MEMORANDUM

Date: 12/8/2021
To: Whom it May Concern
From: Wilson & Girgenti, LLC
RE: Boca Royale Golf and Country Club
1601 Englewood Rd. Englewood, FL 34223

Please see attached report outlining our findings during our site visit on November 9th 2021. It provides detailed explanations of the existing conditions of the electrical, mechanical, plumbing and fire protection systems for the 18,000 square foot golf and country club located at 1601 Englewood Rd, Englewood FL 4223.

Image 1 – HVAC Unit Locations

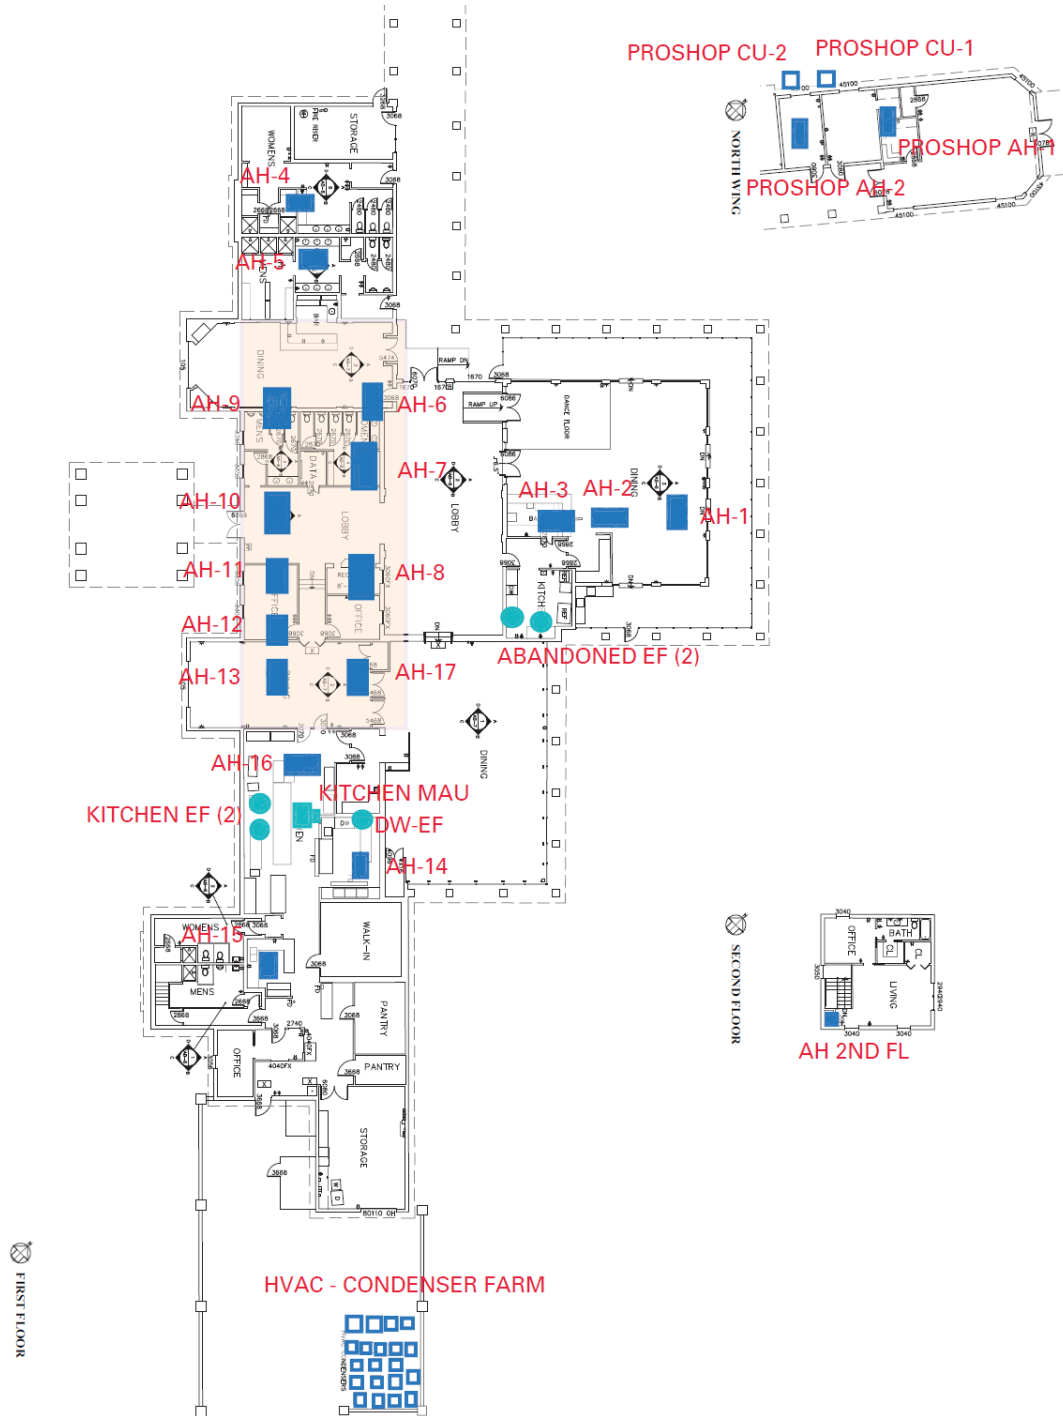
Below explains a summary of the findings during the site visit. A more detailed explanation per unit can be found below on Table 1 with locations shown on Image 1.

<u>WAREHOUSE ROOFTOP UNITS</u>	<u>MFR</u>	<u>MODEL #</u>	<u>TONS</u>	<u>YEAR</u>	<u>REMARKS</u>
Proshop AH/CU 1	TRANE	XE1000 (TTR042D1)	3.5	2000	R22 REFRIGERANT, WE HAD NO ACCESS TO AIR HANDLER, CONDENSING UNIT LOCATED NORTH. UNIT OVER 20 YEARS OLD
Proshop AH/CU 2	TRANE	XB1000 (TTBD18C100A2)	1.5	2000	R22 REFRIGERANT, WE HAD NO ACCESS TO AIR HANDLER, CONDENSING UNIT LOCATED NORTH. UNIT OVER 20 YEARS OLD
CU/AH #1	CU: AMERICAN STANDARD / AH: TRANE	CU: 2TTR3060A1000AA / AH: 4TE3F65B1000BA	5	CU: 2007 / AH: 2011	R410A REFRIGERANT, OUTSIDE AIR OPEN ENDED RECONNECT TO RETURN DUCTWORK, SOME FLEX DUCT WORK IS REUSABLE, REMOVE ABANDONED DUCTWORK
DINING CU/AH #2	AMERISTAR	CU: M4AC4060C1000AA / AH: M4H3060B1000AA	5	2017	R410A REFRIGERANT, AIR HANDLER CABINET IS MOLDY, OUTSIDE AIR CONNECTION OPEN, RETURN DUCTWORK IS NOT REUSABLE (MAIN DUCTWORK IS UNINSULATED), REMOVE ABANDONED DUCTWORK
DINING CU/AH #3	YORK	CU: YCE60B21SA / AH: AE60CBD22G	5	-	R410A REFRIGERANT, MOISTURE SEEN ON UNINSULATED DUCTWORK CAUSING RUST/MOLD

WOMENS RR CU/AH #4	GOODMAN	CU : GSX130301BC / AH: ARUF30B14AC	2.5	-	R410A REFRIGERANT, OUTSIDE AIR / EXHAUST NOT SEALED PROPERLY, MODLY RETURN DUCTOWRK, DRAIN PAN VERY RUSTY

MENS RR CU/AH #5	GOODMAN	CU: G8X130421BC / AH: ARUF42C14AD	3.5	2014	R410A REFRIGERANT, FLEX SUPPLY IN GOOD CONDITION, REMOVE ABANDONED DUCTWORK. MAIN DUCTWORK IN GOOD CONDITION
CU/AH #6	TRANE	CU: 4TTB3048D1000B / AH: TAM4A0C48S41SBA	4	2012	R410A REFRIGERANT
CU/AH #7	AMERISTAR	CU: M4AC4060C1000AA / AH: M4AH30660B1000A A	5	2017	R410A REFRIGERANT, OLD INSULATION
CU/AH #8	TRANE	CU: 2TTR3060A / AH: TWE065E13FB2	5	2006	R22 REFRIGERANT, OPEN OUTSIDE AIR CONNECTION
CU/AH #9	RHEEM	CU: RA1436AJINA / AH: RH1P3617STANIA	3	2016	R410A REFRIGERANT, DUCTWORK NEEDS TO BE REPLACED
CU/AH #10	CU: YORK / AH: JOHNSON CONTROLS	CU: YCE36B22SA / AH: AP36BX21C	3	-	R410A REFRIGERANT, SHORT HARD DUCTWORK WITH FLEX SPIDER DUCTWORK. REPLACE MAIN TRUNKLINE
CU/AH #11	AMERISTAR	CU: M4AC4036C1000AA / AH: M4AH036A1000AA	3	2017	R410A REFRIGERANT, MOLDY UNINSULATED SUPPLY AND RETURN TO BE REAPLCED

CU/AH #12	AMERISTAR	CU: M4AC4060C1000AA / AH: M4AH3060B1000AA	5	CU: 2017 / AH: 2016	R410A REFRIGERANT, MOLDY FLEX DUCTWORK TO BE REPLACED
CU/AH #13	TRANE	CU: TTR060D1100A0 / AH: TWE060C15FD0	5	2001	R22 REFRIGERANT, CONDESATE LINE IS NOT CONNECTED, SPIDER FLEX DUCTWORK, MOLDY DUCTWORK SUPPLY AND RETURN MAINS
CU/AH #14	YORK	CU: YCE48B21SA / AH: AP48CBC21C	4	-	R410A REFRIGERANT DUCTWORK IN GOOD CONDITION
SE KITCHEN & RR CU/AH #15	TRANE (AMERICAN STANDARD)	CU1: 2TTA3060A3000AA / CU2: 2TTR / AH:TWE120B100EL	CU: (2) 5 / AH: 10	2006	R22 REFRIGERANT, DUCTWORK IN GOOD SHAPE, RUSTY DIFFUSERS
MAIN KITCHEN CU/AH #16	TRANE	CU: (2) 2TTA3060A3000A / AH: TWE120B100EL	CU: (2) 5 / AH: 10	2006	R22 REFRIGERANT, RUSTY DIFFUSERS, CONDENSING UNIT HAS EXPOSED REFRIGERANT PIPING, CORED UNDERGROUND TOO CLOSE TO DISCONNECT
CU/AH #17	TRANE	CU: 2TTR1048A1000AA / AH: TEC3F48B100AA	4	2009	R22 REFRIGERANT, MOLDY CABINET, SUPPLY AND RETURN DUCTWORK TO BE REPLACED.

CU/AH 2ND FLOOR	JOHNSON CONTROLS	CU: YCE30B22SA / AH: AP30BBB21C	2.5	-	LIMITED TO NO ACCES TO THE UNIT

**Proshop AH/CU #1,
Proshop AH/CU #2,
AH/CU #8
AH/CU #13
AH/CU #15
AH/CU #16
AH/CU #17**

- Replace main trunk line and return ductwork covered in mold.

- Replace older units as they begin to not perform as intended. Relocate. condensing unit that are running over 200 ft. **(CU #4, CU#5).**
